MONTESSORI SCHOOL OF LAKE NONA

SUMMARY

MASTER PLAN ANALYSIS

FIGURE 1: SURVEY OF SOUTH PROPERTY LINE

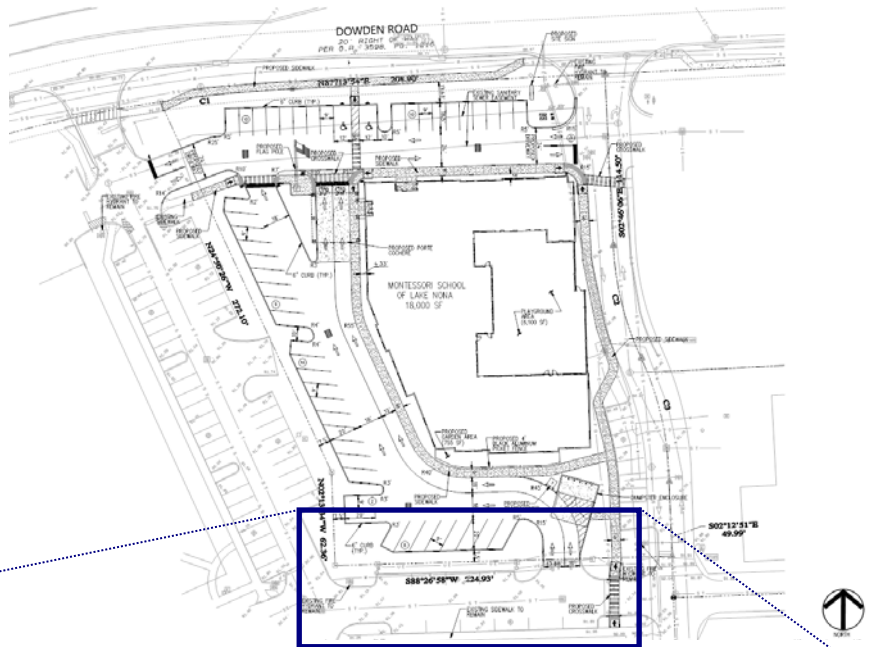
The survey submitted by the applicant shows approximately 6.4 feet from back-of-curb to the south property line, narrowing to 4 feet where light fixtures exist. Staff has concluded that there is suitable space for a 6 foot sidewalk with flexibility to reduce sidewalk width to 4 feet at light fixtures (existing trees can be placed in tree wells).

A 6 ft wide sidewalk shall be extended along the parallel parking spaces on the north side of the south driveway. It shall connect to the proposed sidewalk to the east and shall include MUTCD compliant crosswalks at the entry way and at the driveway on the west side of the parcel. ADA ramps and warning devices shall be included as necessary.

PHOTOMETRIC PLAN

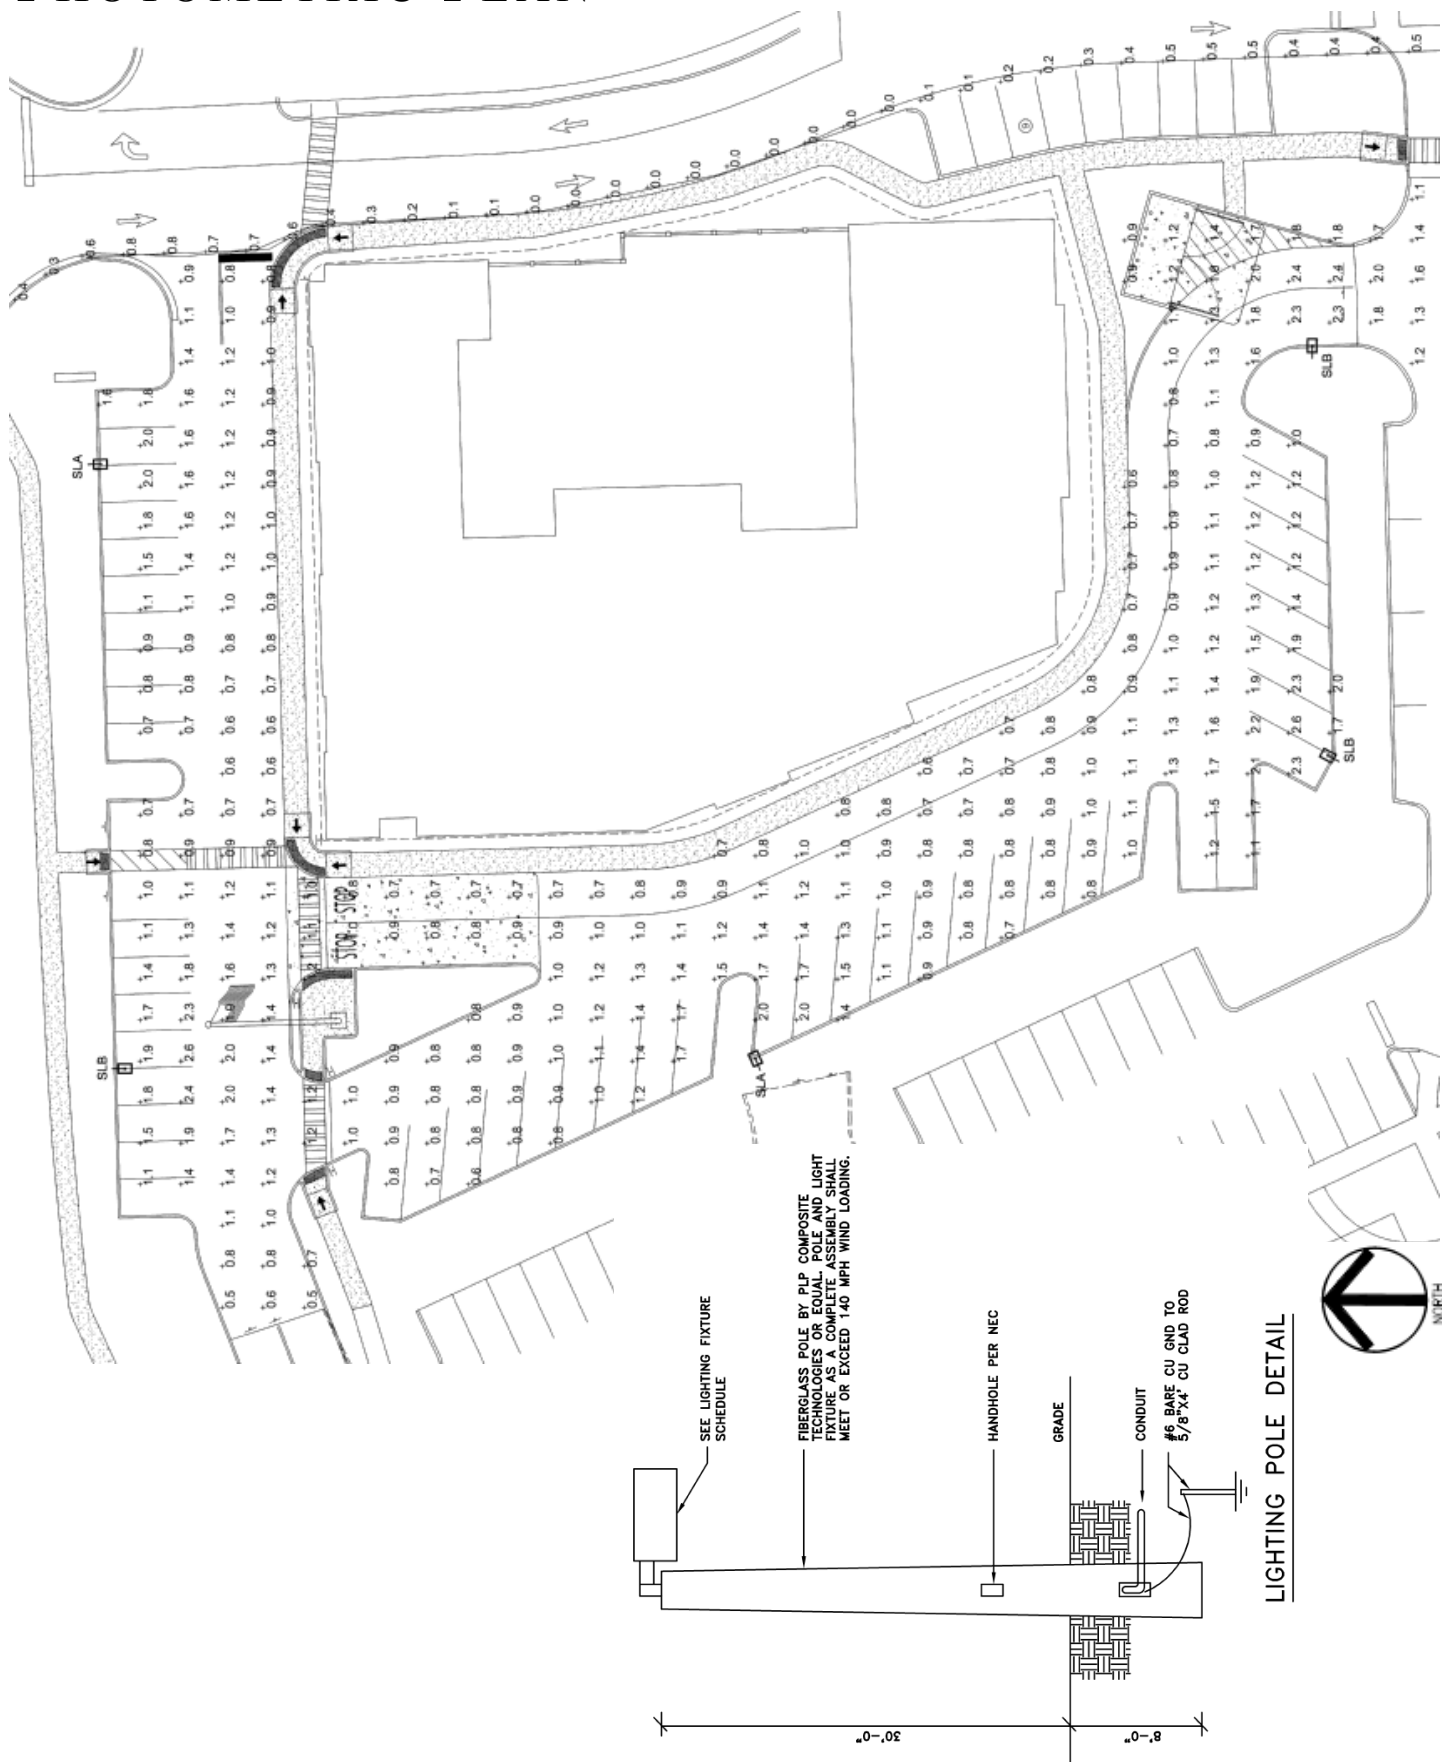
The applicant submitted a Photometric Plan (page 12), all outdoor lighting shall meet LDC Section 63 Part 2M standards.

PRELIMINARY ELEVATIONS

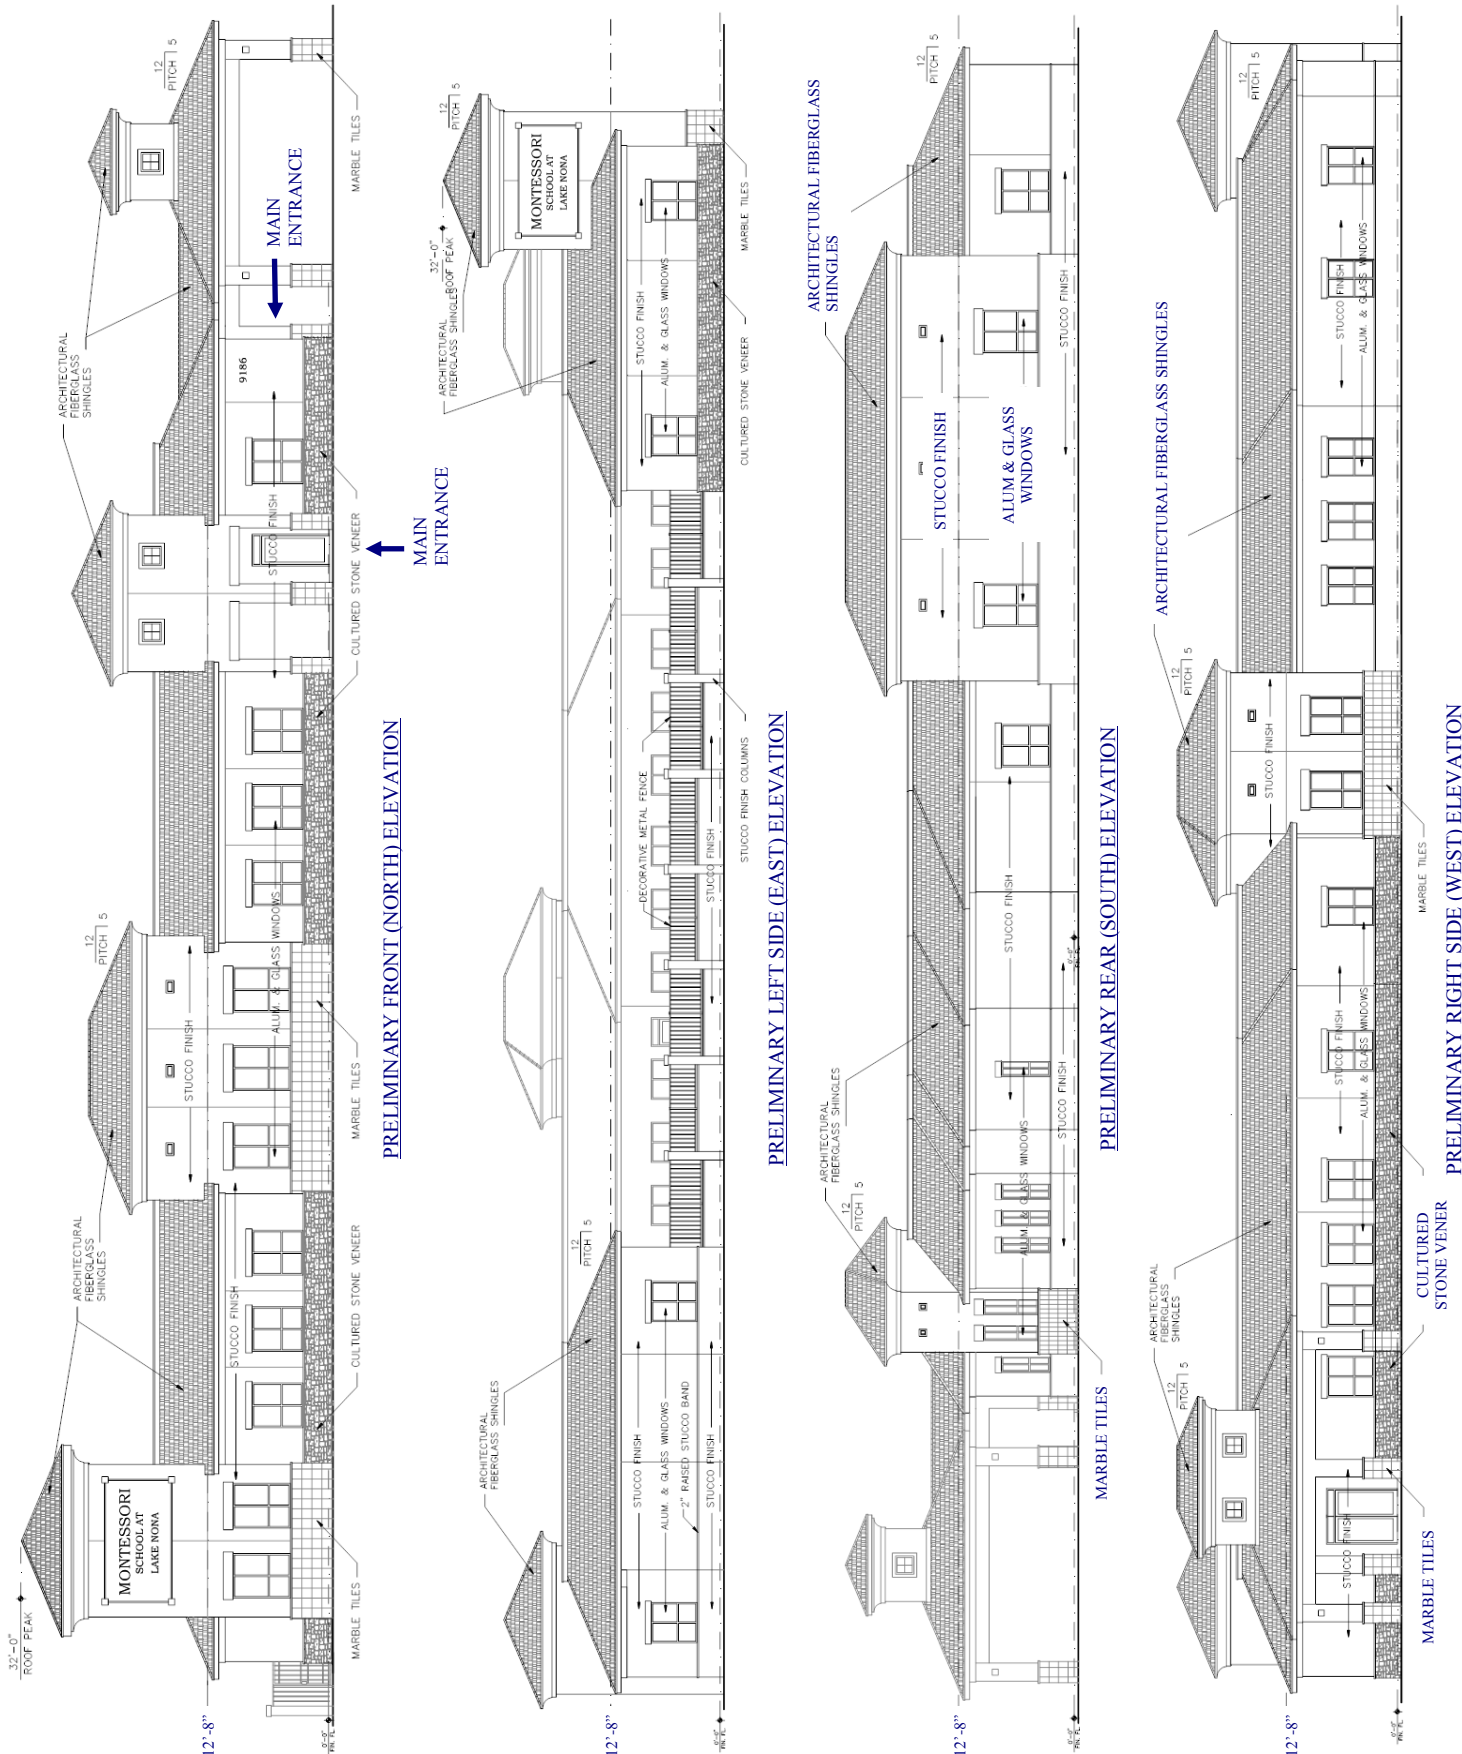
The proposed building fronts on Dowden Rd with 170 linear feet of frontage which results in 340 SF of sign copy area. The proposed elevations on page 12 show two signs on the architectural tower feature (under 30 feet from ground level) each approximately 76 SF in area. The resulting copy area of 152 SF is within the 340 SF maximum allowable area. A complete signage package will be subject to Appearance Review prior to the issuance of building permits and shall be consistent with Chapter 64 of the LDC and the Nona Park Master Sign Plan.

A complete signage package will be subject to Appearance Review prior to the issuance of building permits and shall be consistent with Chapter 64 of the LDC and the Nona Park Master Sign Plan.
